CMD 22-H7.41

Written submission from the Sierra Club Canada Foundation

Application from the CNL to amend its Chalk River Laboratories site licence to authorize the construction of a near surface disposal facility Laboratoires Nucléaires Canadiens (LNC)

Choosing the right disposal option(s) for federal legacy nuclear waste

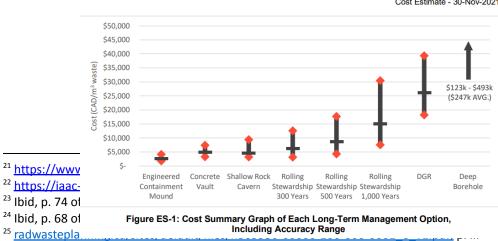
Figure ES-1 in *Nuclear Waste Management Organization - Integrated Strategy for Radioactive Waste Cost Estimate* indicates that the cost of radioactive waste disposal in an engineered containment mound is around \$2500 per cubic meter of waste. The cost for disposal in a concrete vault or a shallow rock cavern would be twice as high, at around \$5000/m³.²⁵

As noted above, the average cost for waste disposal in an engineered containment mound is \$2500 per cubic meter (m³) of waste. This suggests that the \$750 million estimate (p. 280 of the *Safety Case*²⁹) for disposal of a million cubic meters of waste in the NSDF, which translates to \$750 per m³, may be a 5-fold underestimate, even without taking into account the added costs of segregation and sorting.

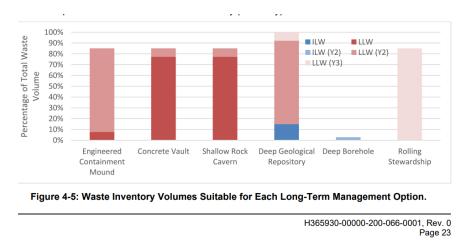
Nuclear Waste Management Organization - Integrated Strategy for Radioactive Waste Cost Estimate - 30-Nov-2021 According to Figure 4-5 in *Nuclear Waste Management Organization - Integrated Strategy for Radioactive Waste Project Report,* much of the current radioactive waste inventory may be unsuitable for disposal in an engineered containment mound.²⁶ Table 4-1 in this report indicates that the need for accurate waste characterization related to a specific safety case creates this uncertainty about the total waste volume suitable for disposal in an engineered containment mound.²⁷
